REPORT TO CITY PLAN COMMISSION

Item: Final Plat – Trail View Estates South 3

Petitioner's Request: The applicant is proposing to subdivide the property into 76 lots and one outlot for single-family residential development.

Revision Date: Jun 28, 2022
 File: 6025Final3.dwg
 Date: 06/28/2022
 Drafted By: Jim
 Sheet: 1 of 3

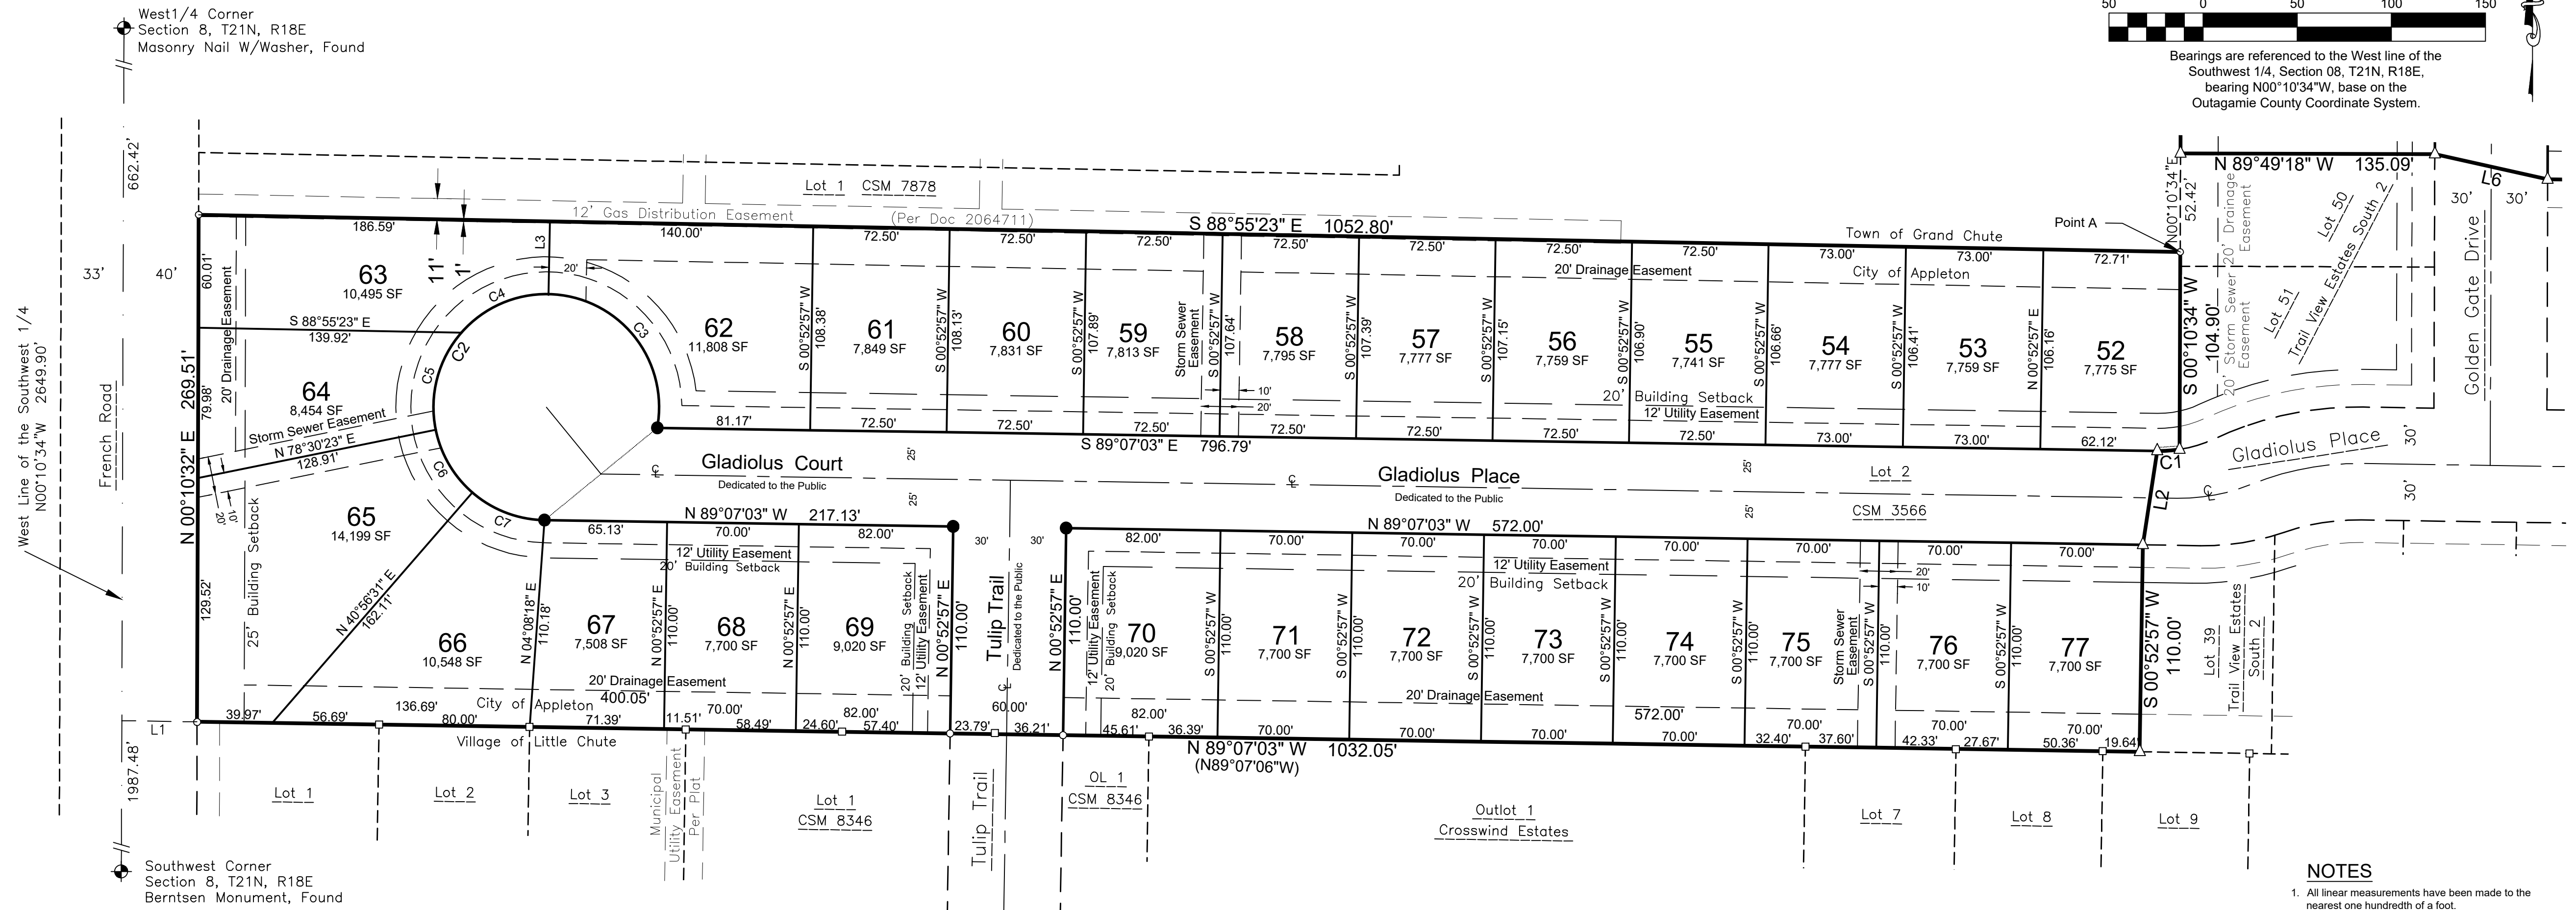
7. Near Lots 97 and 98, the label for the 12' utility easement appears to be in the wrong location. Revise as necessary.
8. Provide a 15-foot-wide sanitary sewer easement centered on the Lot 56/57 property line to accommodate future sanitary sewer extension from Gladiolus Place to lands north of the plat.

9. On Sheet 2 of the plat, modify the callout for Outlot 1 to read as follows: Dedicated to the public for trail and water main purposes.
10. For all "Storm Sewer" Easements shown on the plat, revise the description to read "Storm Sewer and Drainage" Easement.

11. Provide a Storm Sewer and Drainage Easement between Lots 62 and 63.
12. On the south side of Lots 69 and 70, revise the description of the "20' Drainage Easement" to read "20' Storm Sewer and Drainage Easement," to accommodate the proposed storm sewers.

13. On the south side of Lot 117, revise the description of the "15' Drainage Easement" to read "15' Storm Sewer and Drainage Easement," to accommodate the proposed storm sewers.

14. On the South side of Lot 127, revise the 15' drainage easement to read 15' Storm Sewer and Drainage Easement, to accommodate the proposed storm sewer.

15. On the North side of Lot 103 and 104, revise the 15' drainage easement to read 15' Storm Sewer and Drainage Easement, to accommodate the proposed storm sewer.

16. The open circle symbol shown on the map portions of sheets 1 and 2 are missing from the corresponding legends, add a description for the open circle symbols to the legends.

17. The scale of some of the map symbols do not match the scale of the corresponding symbols shown in the legend, revise as necessary.
18. The exterior boundary map bearing/distance of N50°02'12"E 414.42' does not match the corresponding bearing/distance of N50°02'12"E 414.41' shown in the surveyor's certificate.
